RE: The Point South Phase 3
Case Number: FSP-25-02
Response to 1st F6 Plat Review Comments
AWH20000

Sheet 3

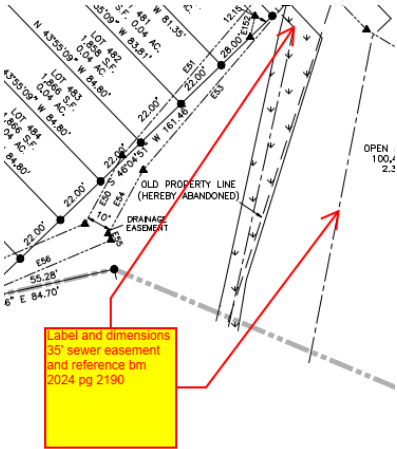
- 2. Label and dimensions 35' sewer easement and reference bm 2024 pg 2190.

- 3. Give ties along phase line, label adjoining phase and provide reference(s).

4. Bm 2024 pg 2190.

5. Provide grid coordinates or grid tie. Provide reference or statement of how the coordinates were derived. (does not have to be at this specific point).

McAdams Response: This has been added.

McAdams Response: Tie added.

McAdams Response: Reference added.

McAdams Response: Grid coords added.
